[Docket No. 96–CE–09–AD; Amendment 39–10864; AD 97–01–01 R1]

Airworthiness Directives; The New Piper Aircraft, Inc. PA–24, PA–28R, PA–30, PA–32R, PA–34, and PA–39 Series Airplanes

ACTION: Final rule.

Figure 1

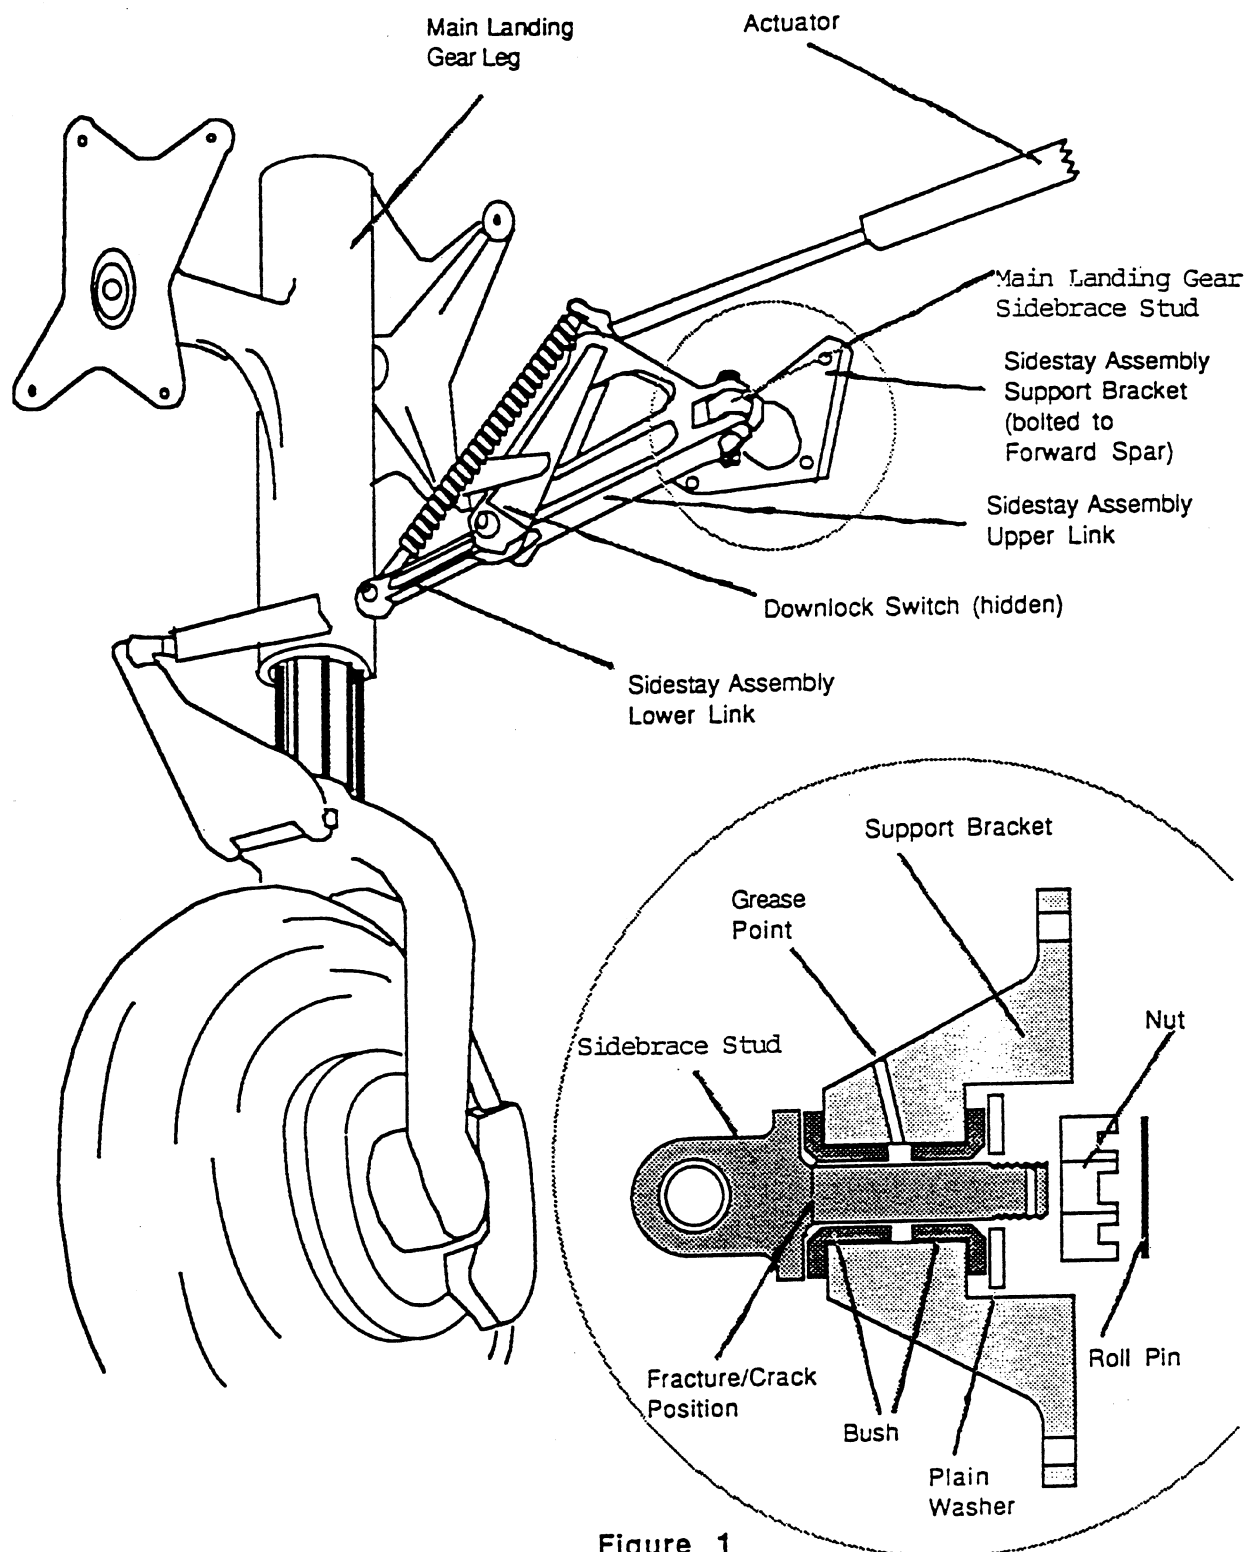
(a) Remove both the left and right main gear sidebrace studs from the airplane in accordance with the instructions contained in the Landing Gear section of the maintenance manual, and inspect each main gear sidebrace stud for cracks, using Type I (fluorescent) liquid penetrant or magnetic particle inspection methods. Figure 1 of this AD depicts the area of the sidebrace stud shank where the sidebrace stud is to be inspected.

(1) For any main gear sidebrace stud found cracked, prior to further flight, replace the cracked stud with an FAA-approved serviceable part (part numbers referenced in the table in paragraph (b) of this AD or FAA-approved equivalent part number) in accordance with the instructions contained in the Landing Gear section of the applicable maintenance manual, and accomplish one of the following, as applicable:
